ServiceNews

March 2002

Installation Instruction Fix: Security System, '02 CR-V

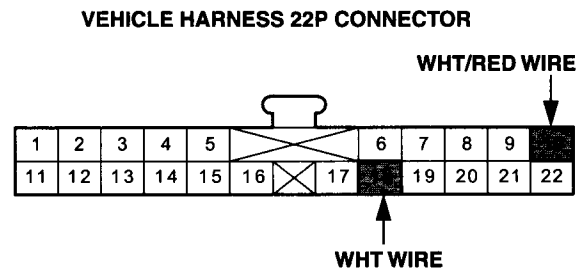
If you've used AII 23086, *Security System*, to install the accessory security system in an '02 CR-V, you might have noticed the illustration in step 16 for the vehicle harness 22P connector is a little tough to follow. The actual connector has more cavities than what's shown in the illustration, so it's hard to tell just where to insert the WHT and WHT/RED wires. Here's a connector diagram that will make it clear:

The WHT/RED wire goes to the security unit, and it is hot at all times. The WHT wire goes to the security system LED. If these wires are inserted in the wrong cavities, the LED or possibly the entire security system may not work.
